**Planning Commission Meeting Agenda**

Tuesday, January 3, 2023, 5:30 PM

Class C Major Single Family Development Review Staff Report

**Planning Commission Staff Report**

**South Elevation**  
Scale: 1/4" = 1'-0"

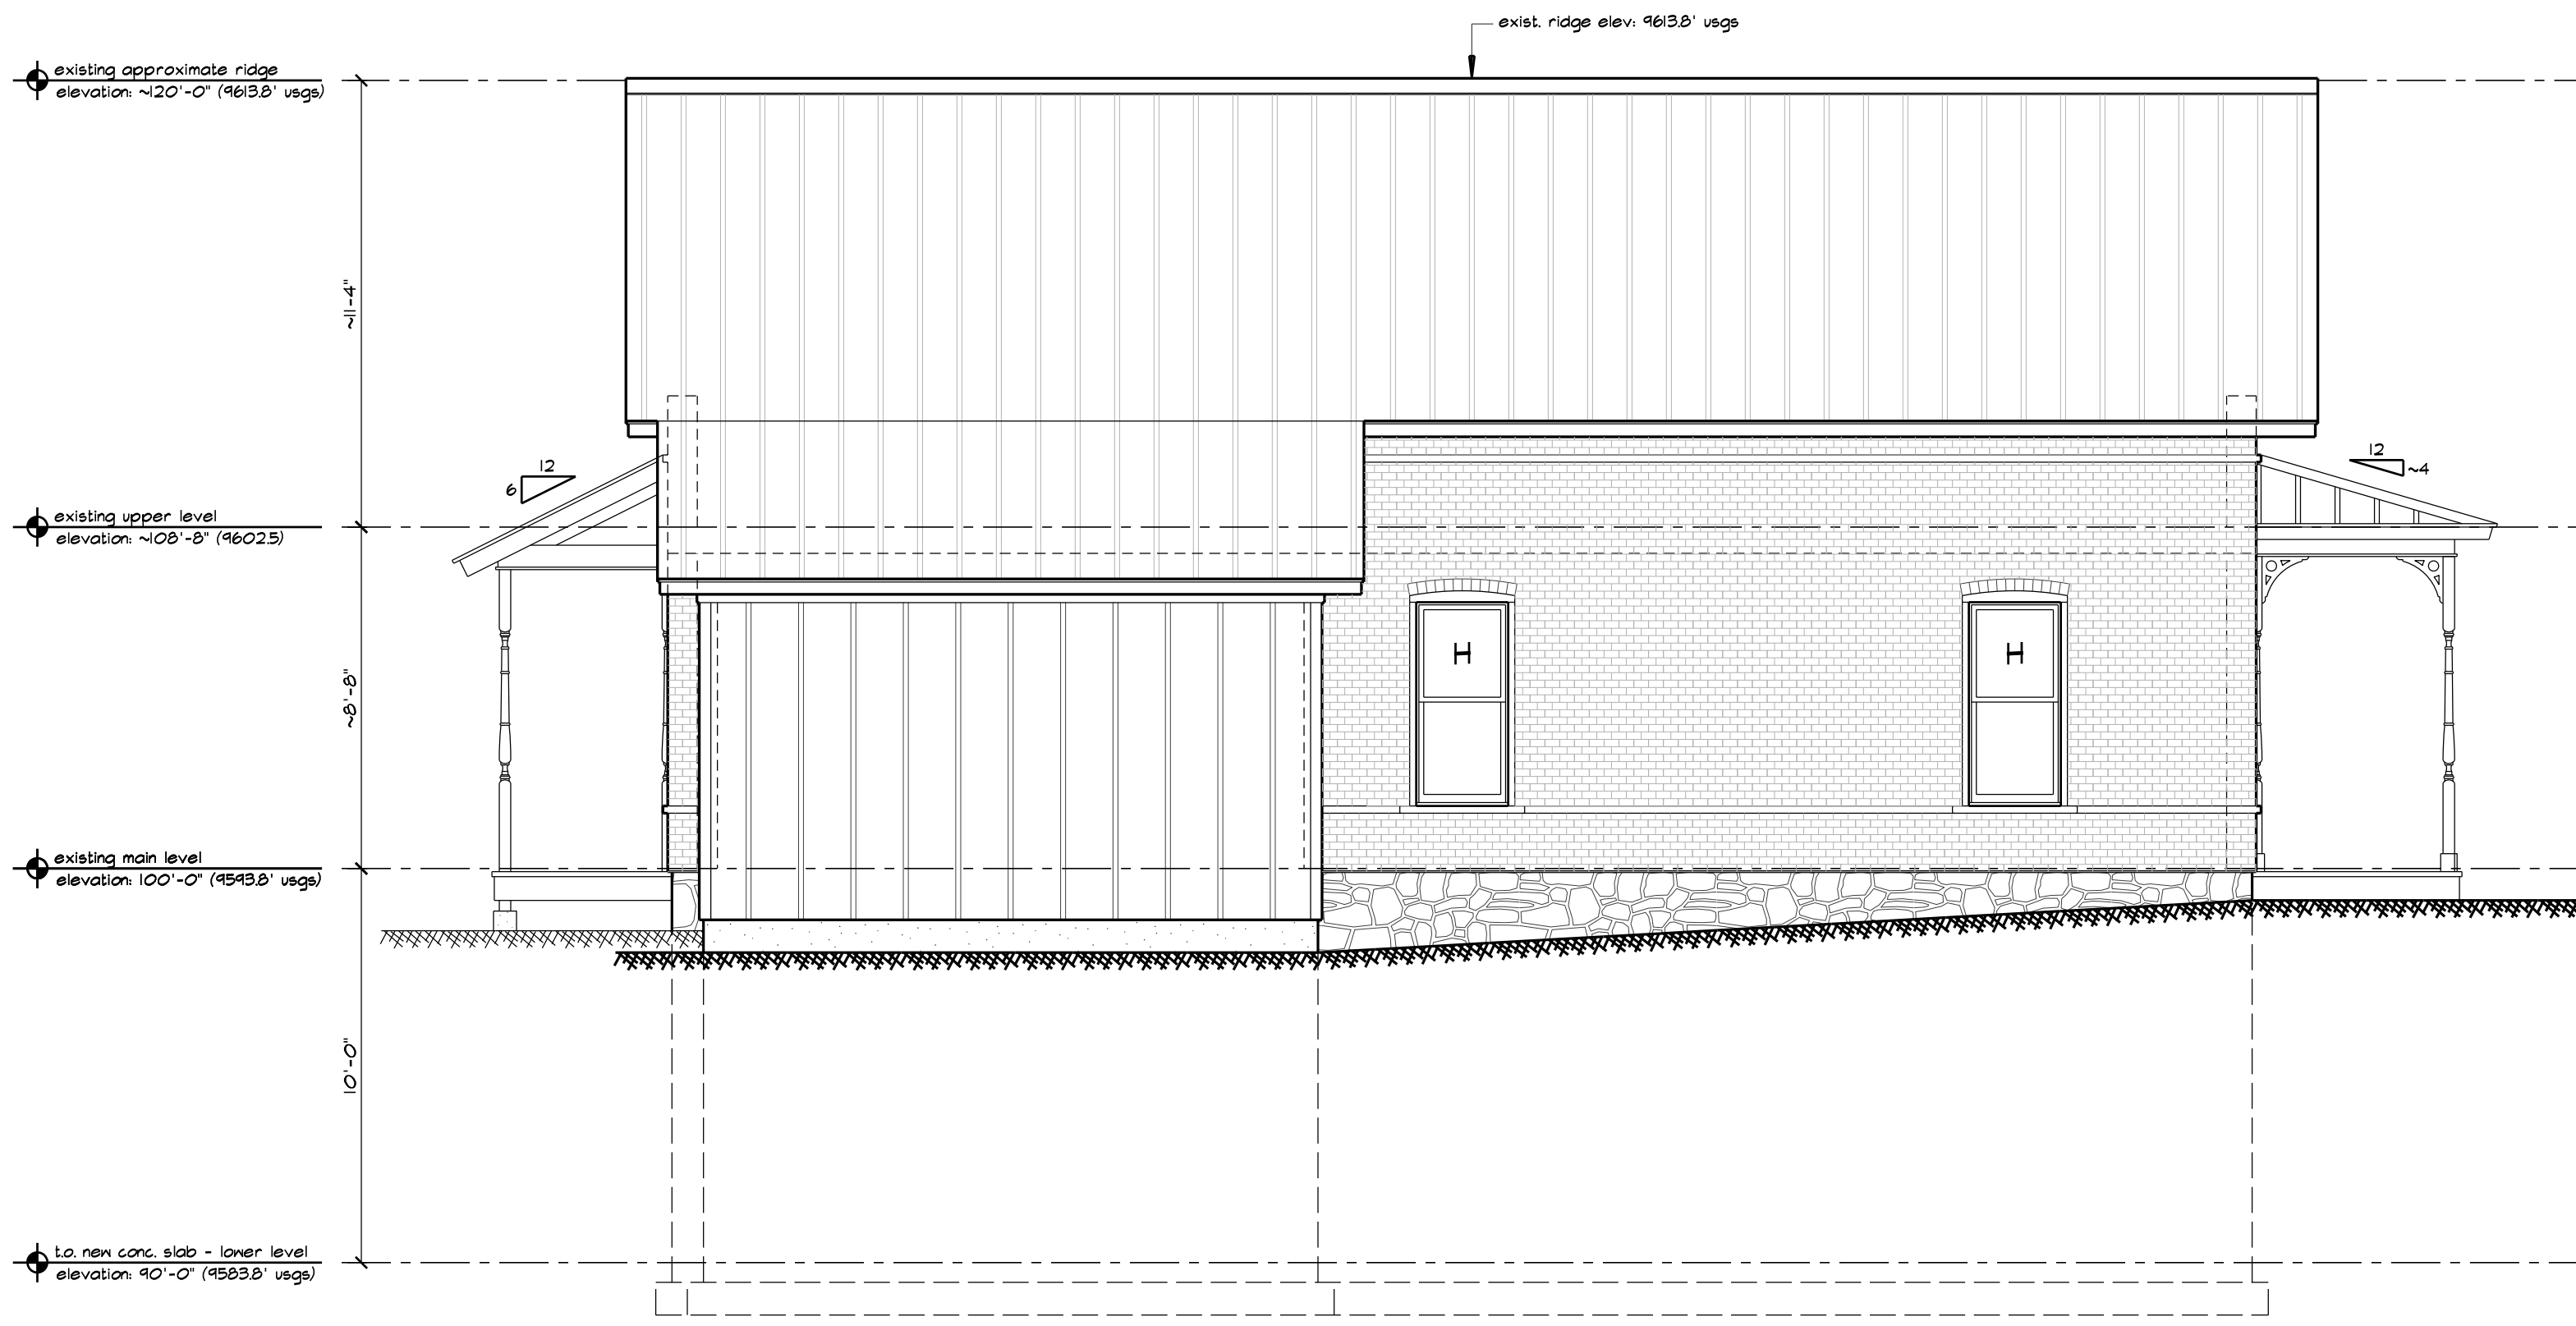
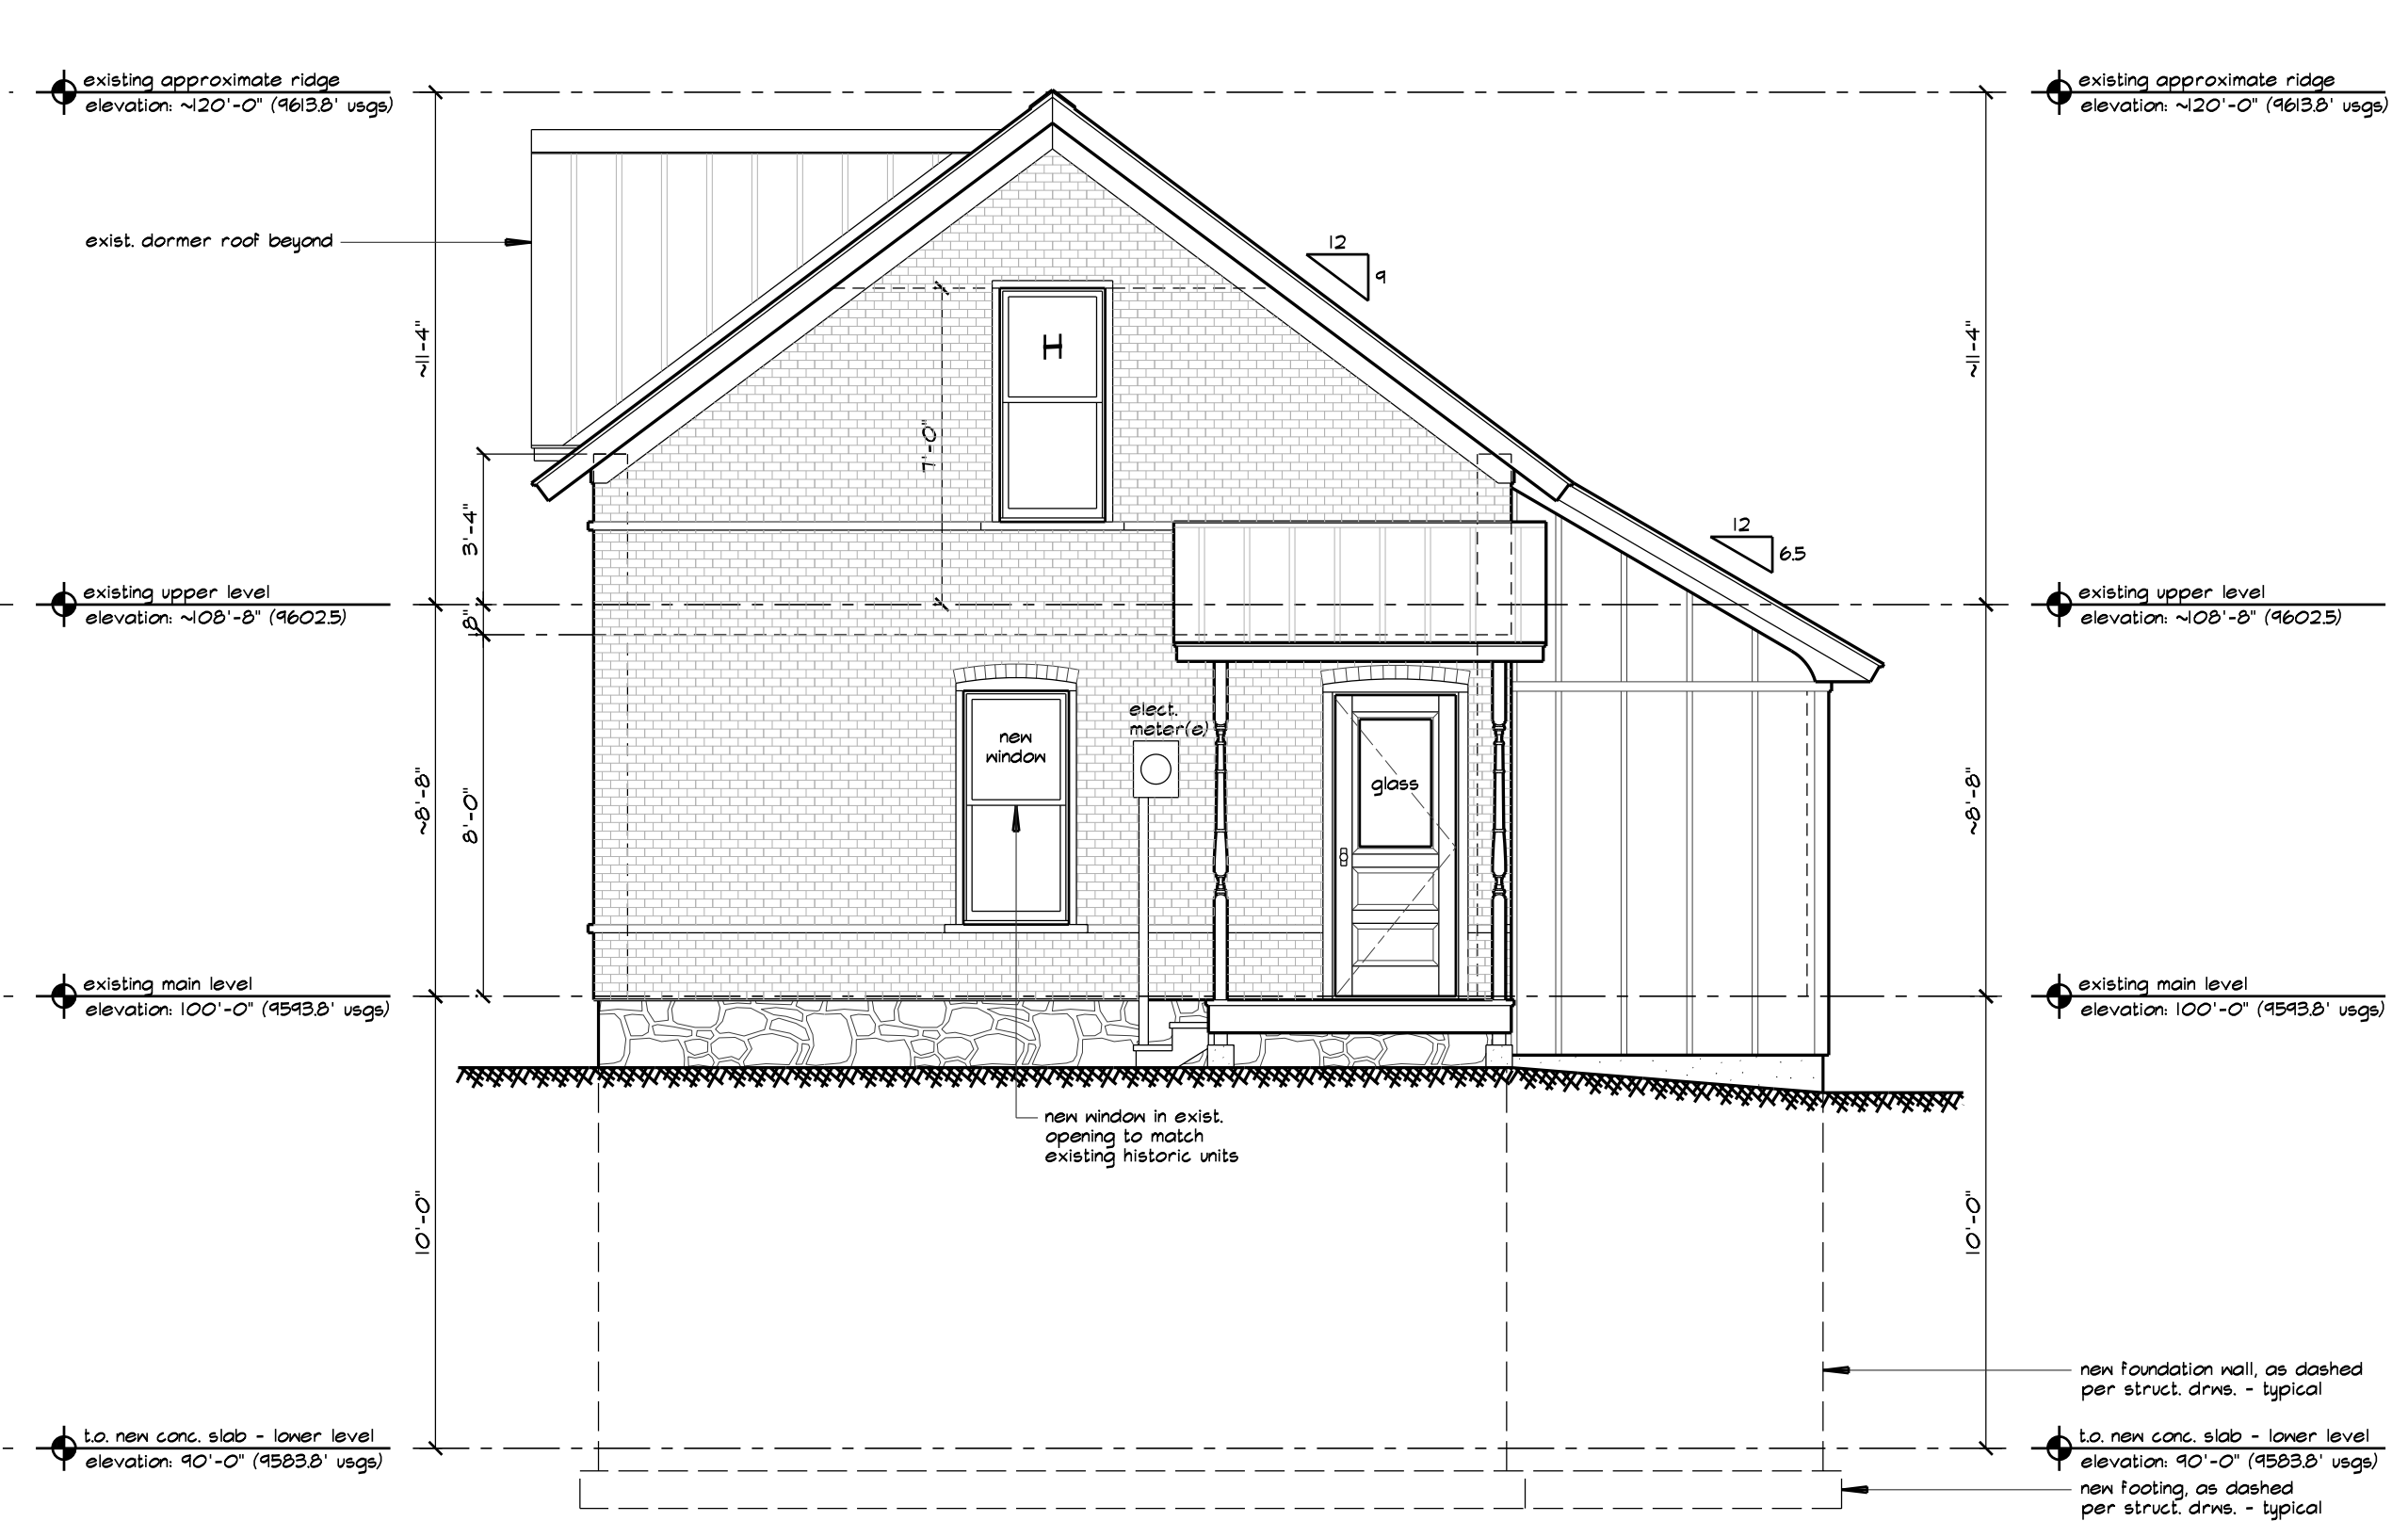
Priority Design Standard 95 states, *“The proportions of window and door openings should be similar to historic buildings in the area”* and that *“this is an important design standard.”* Priority Design Standard 96 further emphasizes the importance of window proportions, *“Use a ratio of solid to void that is similar to those found on historic and supporting buildings.”* Design Standard 91 again reinforces the use of windows that are in a similar size and shape found historically, *“Use building components that are similar in size and shape to those found historically along the street”* and specifically states, *“these include windows, doors and porches.”* The applicant is proposing to reestablish an enclosed door opening on the eastern façade and an enclosed window on the northern façade but would prefer to convert the opening into a space for a double-hung window that matches the other double hung windows on the eastern façade. Staff believes this opening should remain a doorway, does the Commission concur?

The eastern façade’s proposed half-light door is a style that was typical of the character area and the proposed double-hung window will match the other existing double hung windows on the primary historic residence. Staff notes, the sideways double hung window in the upper gable of the eastern façade is original, although it is an odd orientation.

**Proposed Garage**

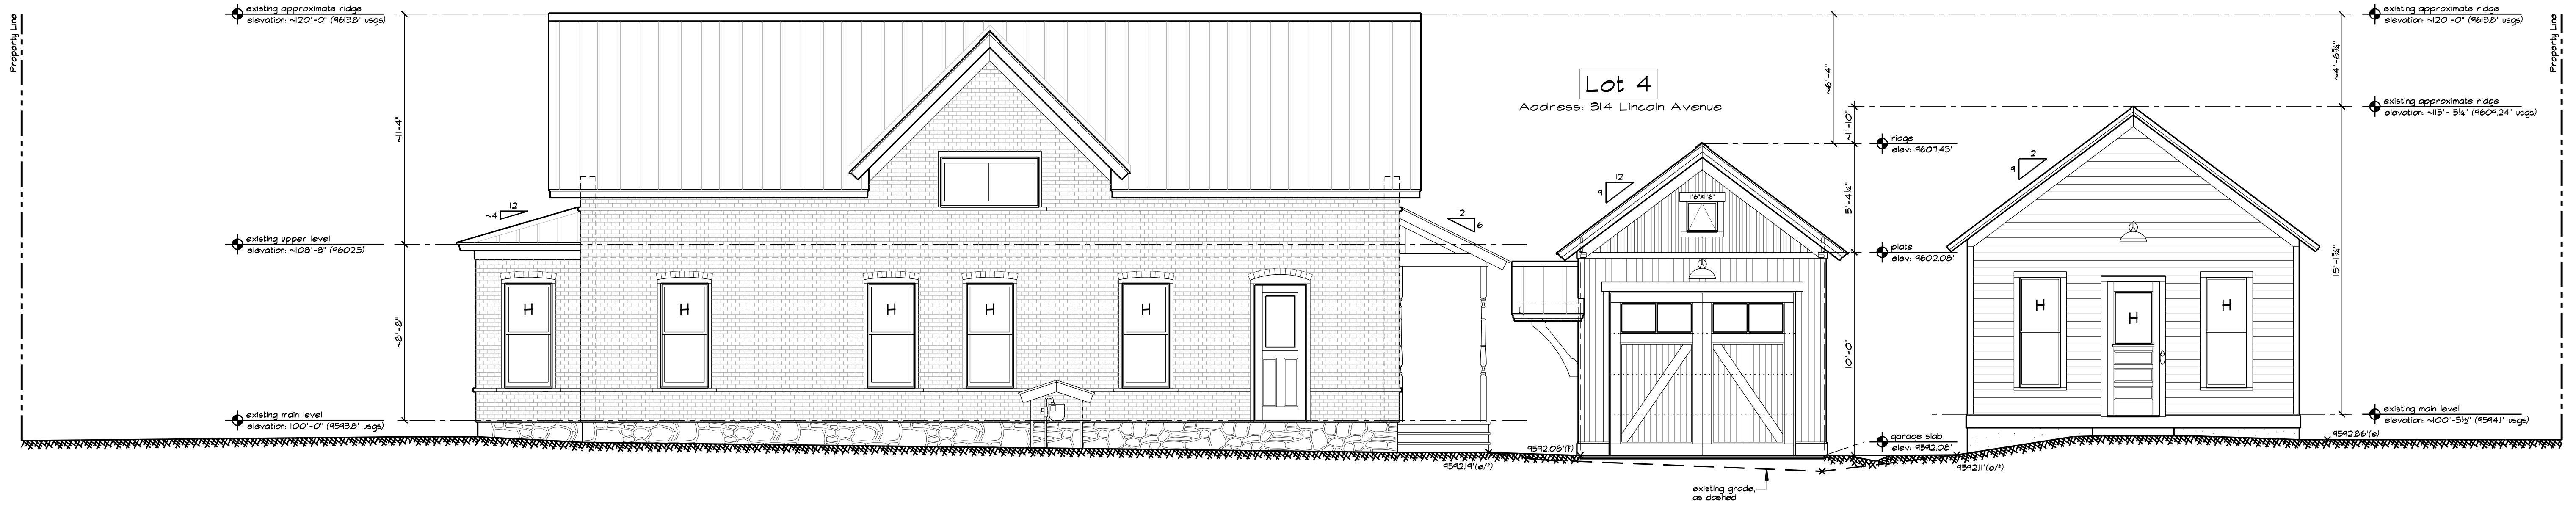
Staff feels the roof design on the proposed garage building meets the intent of this design standard because it features a simple gable roof that has an east-west orientation, differentiating from the primary historic structure which runs north-south (the historic secondary structure also runs east-west). Staff has no concerns.

The garage structure is proposed to be a dark stained board on board vertical wood siding. There will be a lower band board matching the secondary structure, and a stone veneer matching the primary structure. A metal roof is proposed, matching the primary structure as well. There will be a corrugated metal siding within the gable end with a rusted finished. Based on staff research, this material has been shown on existing historic structures in this character area, and not just on lower facades. The applicant will provide a colored material board prior to final hearing. Staff has no concerns.
